ADA Curb Ramp New Construction Inspection Form (Perpendicular)

Nw 292nd

23885.56

Nw Fair

PERPENDICULAR RAMP (PR)

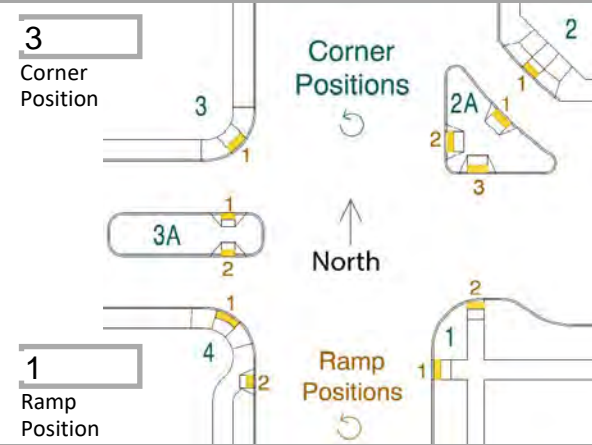
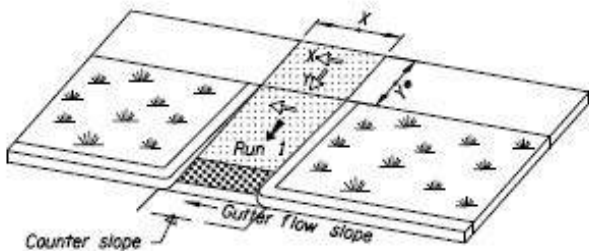
IITD RR1 Fails
